1st Further Information

**Proposed Temporary Open Storage of Construction Material and Machinery with
Ancillary Facilities for a Period of 3 Years and Associated Filling of Land
in “Agriculture” Zone, Various Lots in D.D. 82, Ta Kwu Ling, New Territories**

(S.16 Planning Application No. A/NE-TKL/761)

Responses-to-Comments

DRAWING TITLE
PROPOSED DRAINAGE SYSTEM

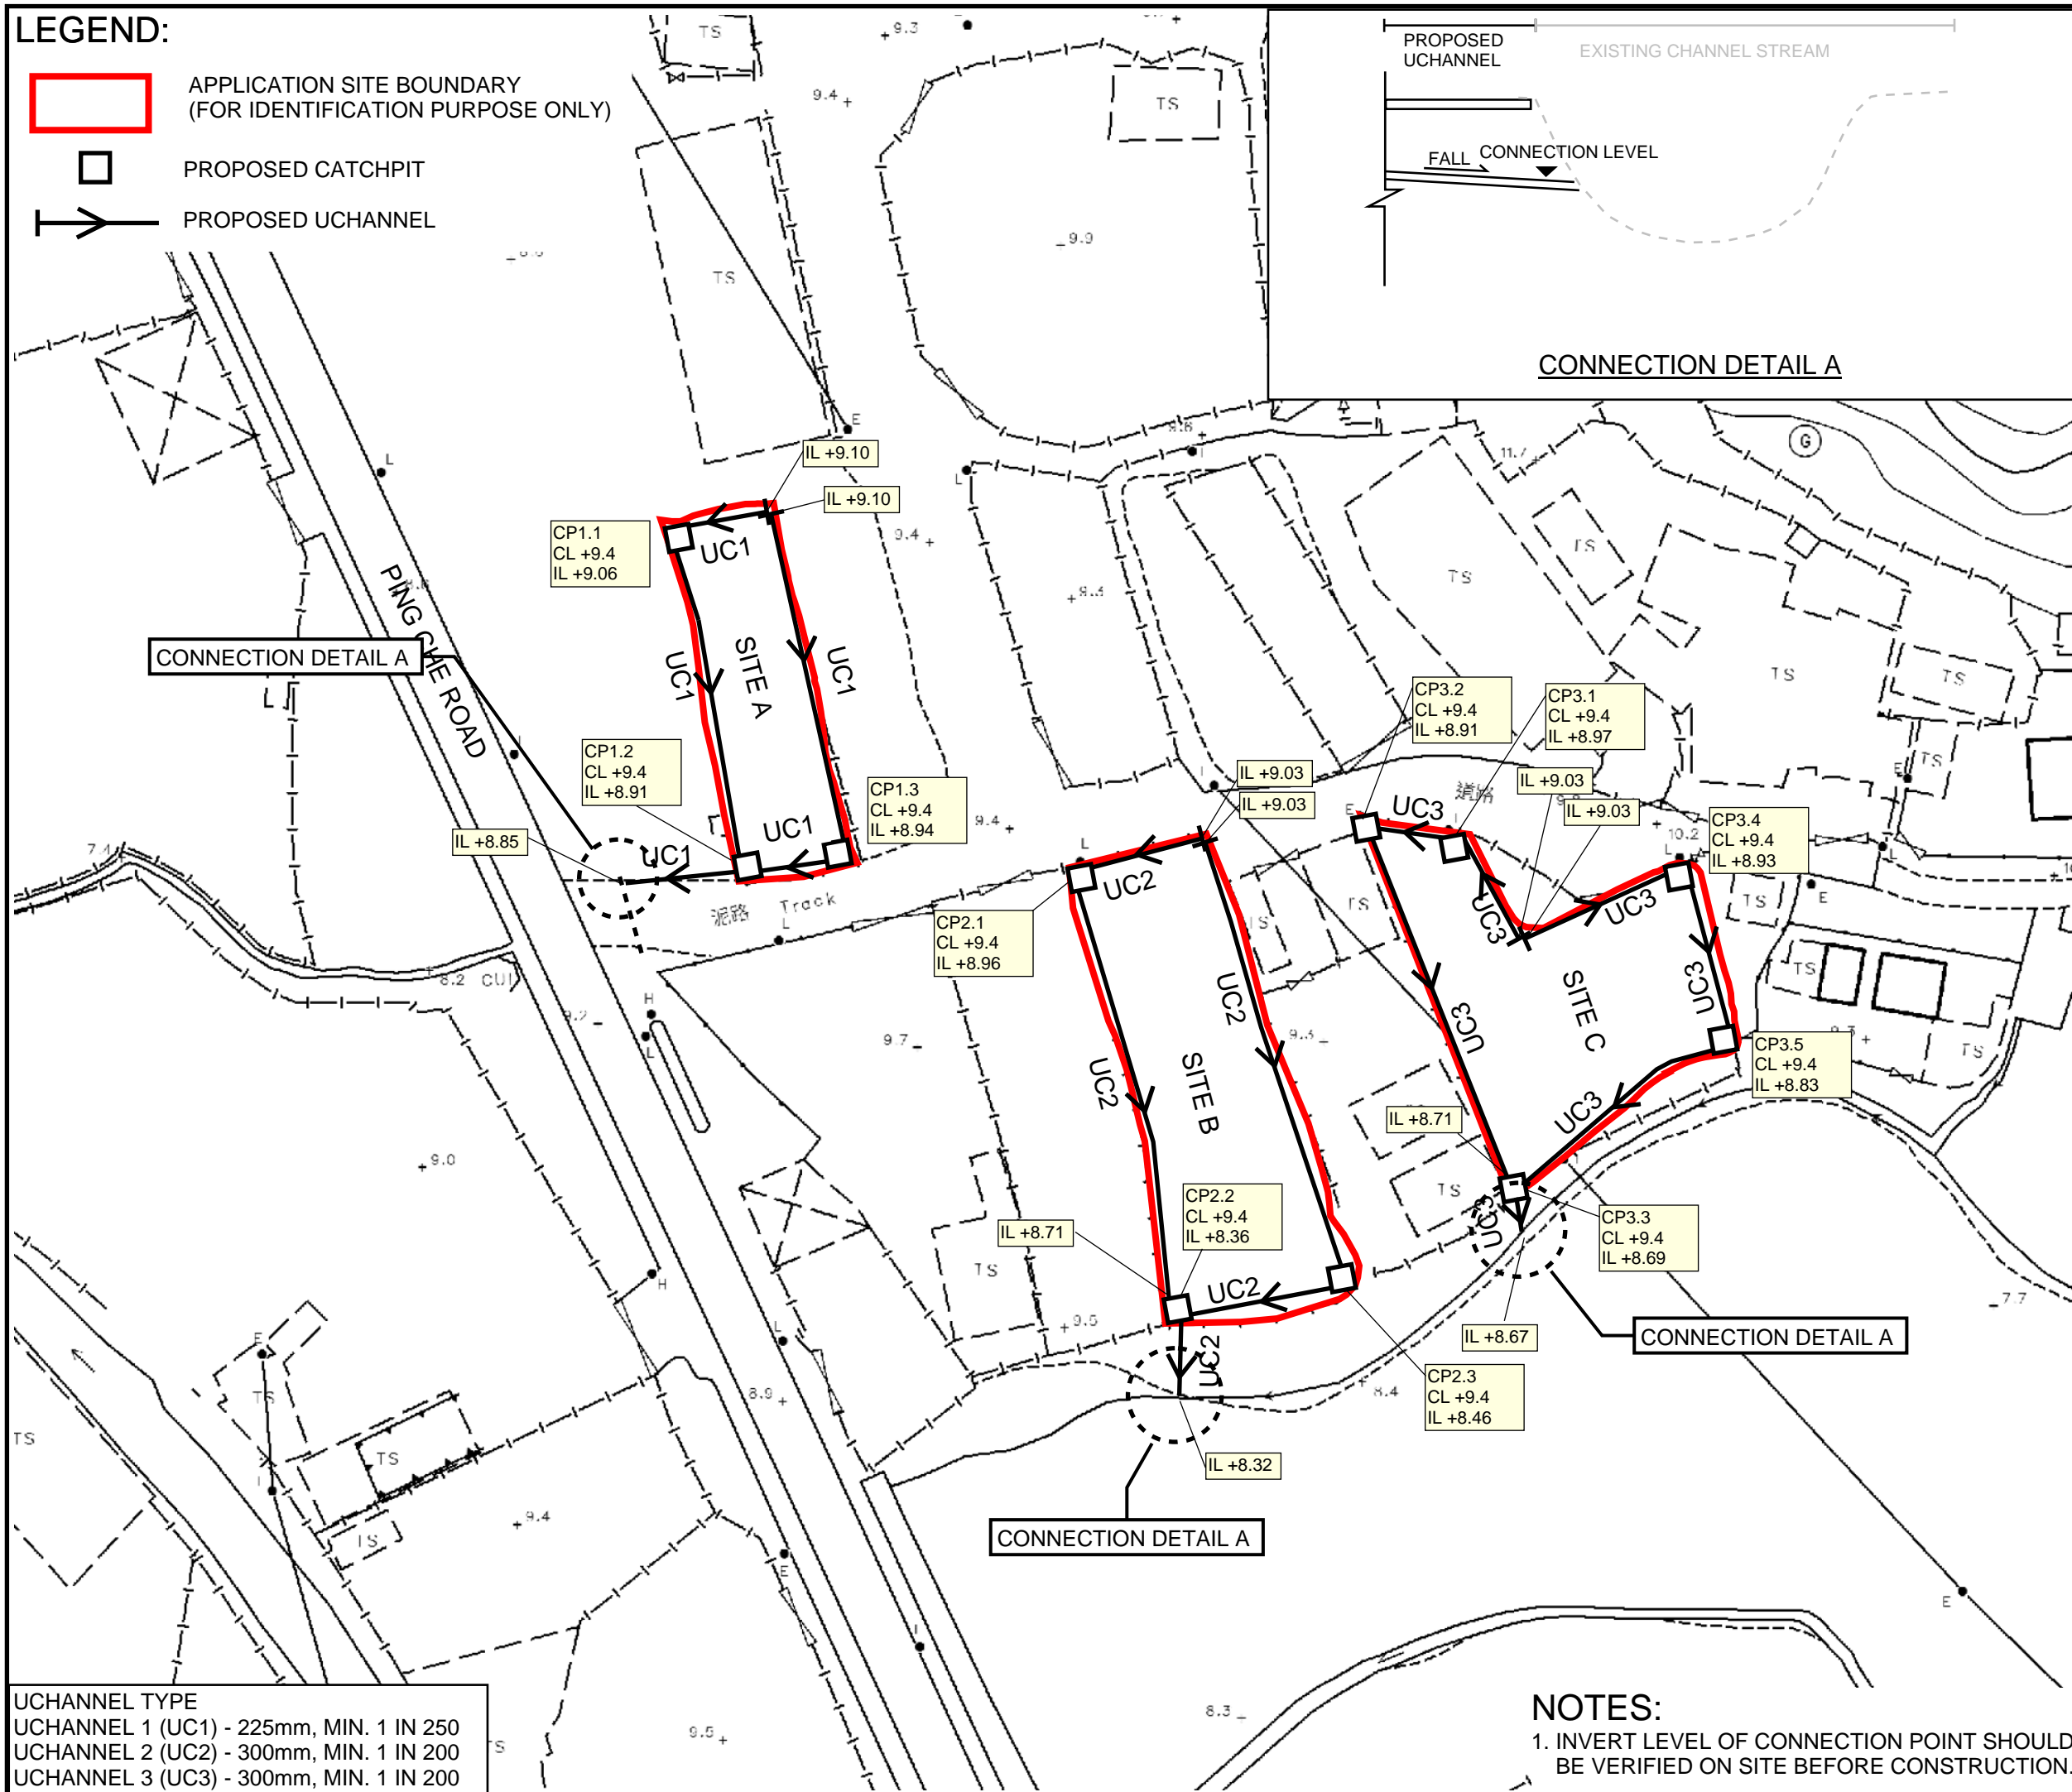
2. Comments of the Chief Engineer/Mainland North, Drainage Services Department (CE/MN, DSD)		
(a)	Flooding complaints have been recorded based on our records. It is revealed that the area adjoining the application site is subject to overland flows and/or regular flooding.	A drainage proposal is prepared by the applicant to mitigate the flooding susceptibility of the area (Annex I). According to the result of the drainage proposal, with

Unless the applicant can submit satisfactory drainage proposal to mitigate the flooding susceptibility of the area to my satisfaction, I do not support the application.	the implementation of the proposed drainage system, adverse drainage impact to the surrounding area is <u>not</u> anticipated.
(b)	The site is in an area where public sewerage connection is not available. EPD should be consulted regarding the sewage impact assessment and sewage treatment/disposal facilities for the proposed development.	Majority of the Site is proposed of 'open storage' use, while the remaining area is proposed for circulation of vehicles. Please be informed that no structure and washroom is proposed at the Site, therefore, adverse sewerage impact to the surrounding area should not be anticipated.

- 4.1.1 Proposed U-channels are designed for collection of runoff within and near the Development Site. Please refer to the **Figure 4** for proposed catchment plan. The U-channels are proposed to be connect and discharge to existing channel/stream. The design calculations of proposed UChannels are shown in **Appendix A**.
- 4.1.2 The alignment, size, gradient and details of the proposed drains are shown in **Figure 3**.
- 4.1.3 The reference standard drawings of drains are shown in **Appendix C**.

DWG. TITLE
LANDSCAPE PROPOSAL

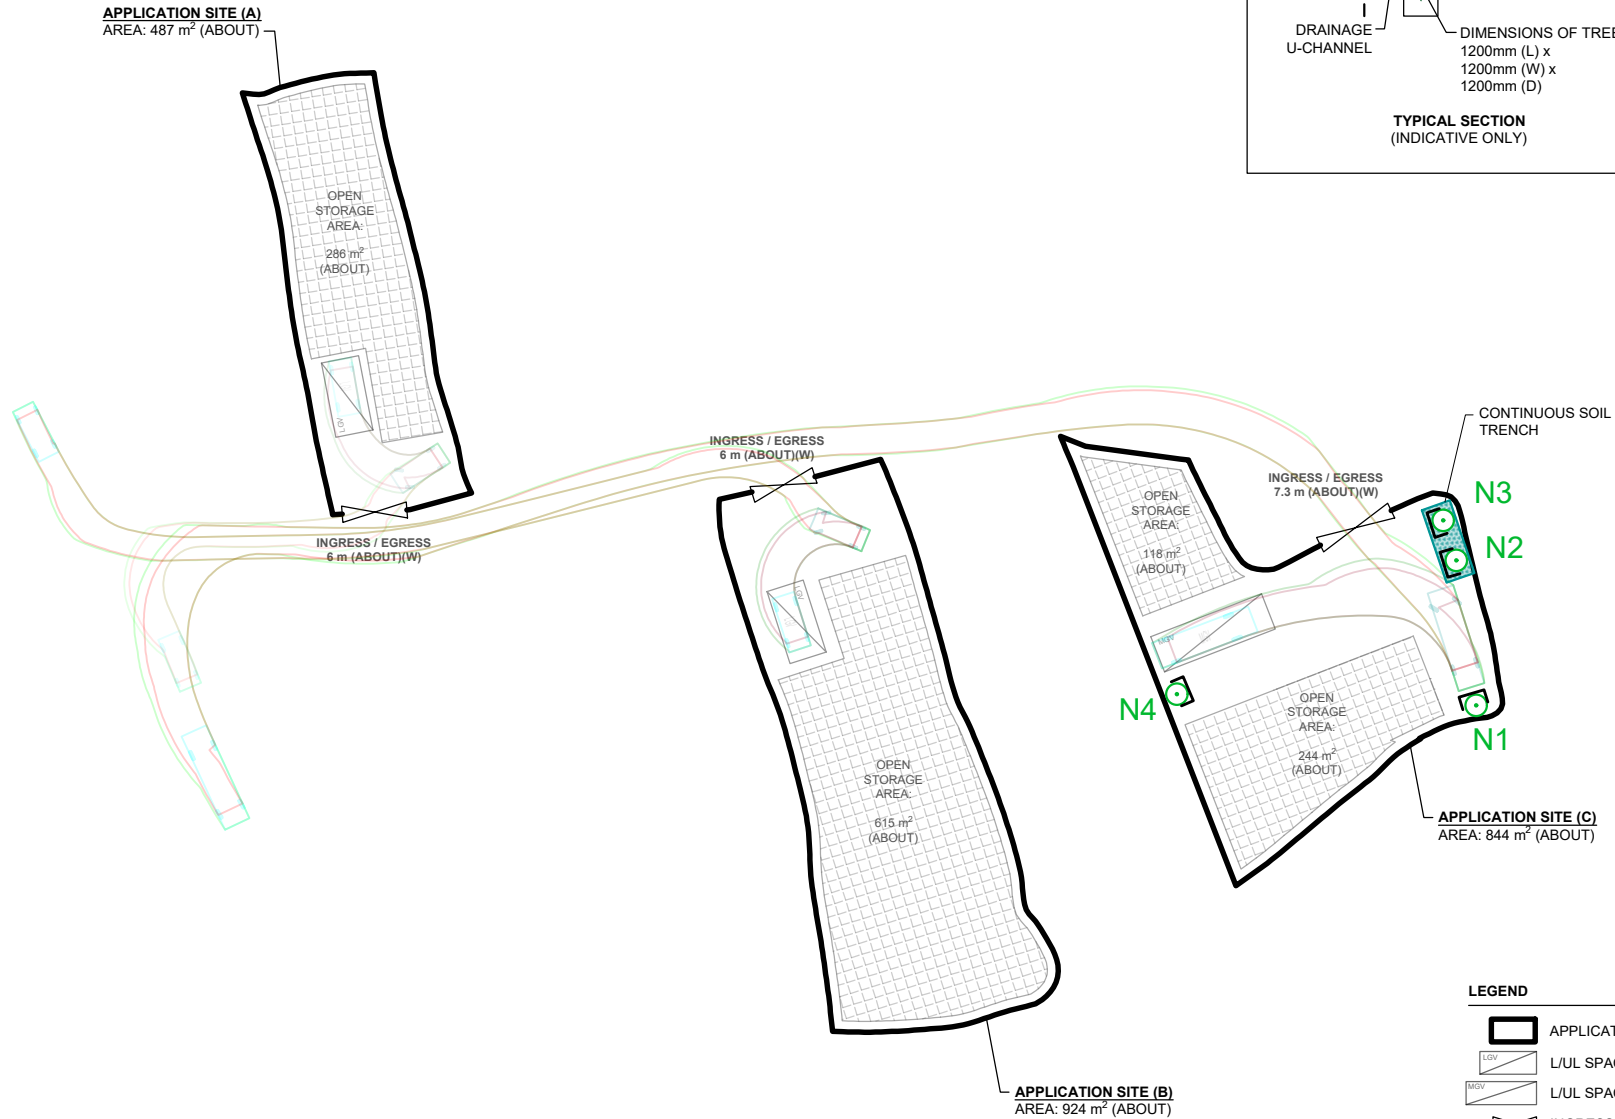
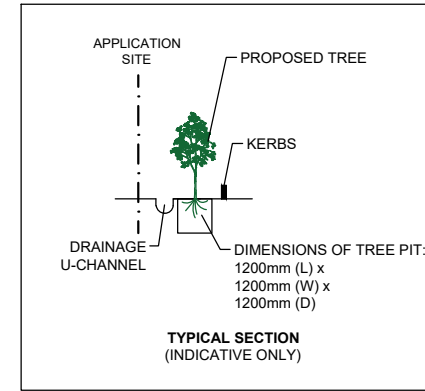
(c)	Annex II Landscape Proposal – "1" is indicated at "No. of new trees will be planted" and is inconsistent with the illustration of trees (i.e. N1 to N4) on plan. Please review and rectify.	It is revised accordingly.

(d)	The applicant is advised to provide larger tree pit (i.e. around 1.2m (W) x 1.2m (L) x 1.2m (D)) to sustain the growth of new trees wherever appropriate. As tree N2 and N3 are close to each other, the applicant is advised to provide continuous soil trench/planter for better root growth.	Larger tree pit (i.e. around 1.2m (W) x 1.2m (L) x 1.2m (D)) will be provided to sustain the growth of new trees. Continuous soil trench for tree N2 and N3 will also be provided for better root growth.

NO. OF NEW TREES WILL BE PLANTED : 4 (N1 TO N4)
 SPECIES OF NEW TREES : *SENNA SURATTENSIS*
 HEIGHT OF NEW TREES : NO LESS THAN 2.75 m
 SPACING OF NEW TREES : NOT MORE THAN 4 m
 DIMENSION OF TREE PITS : 1.2 m (W) X 1.2 m (L) X 1.2 m (D)
